Technical Service Information

THM 4L60 (700-R4) T.V. EXHAUST VALVE

Figure 1 Figure 2

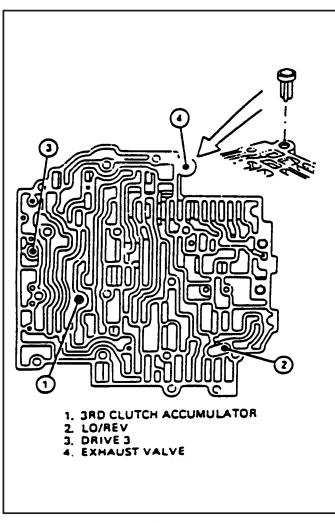
The 1982/83 Models of the THM 700 R4 did not come with a TV Exhaust valve I4 (Figure 1). All Information that was published prior to production will show this valve, however it was never installed.

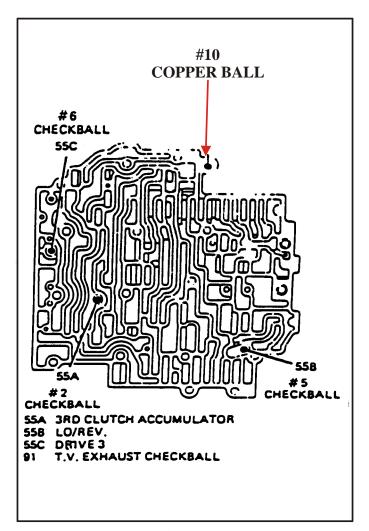
For 1984, there is now a I 10 check ball as shown in (Figure 2) this check ball is larger in diameter than the others, and can easily be identified by its dark copper color. Also note that the check balls have been renumbered.

The intent of cht # 10 check ball is to protect the transmission in the event of a broken or unhooked cable. Causing a late or no upshift condition. We recommend leaving this check ball out
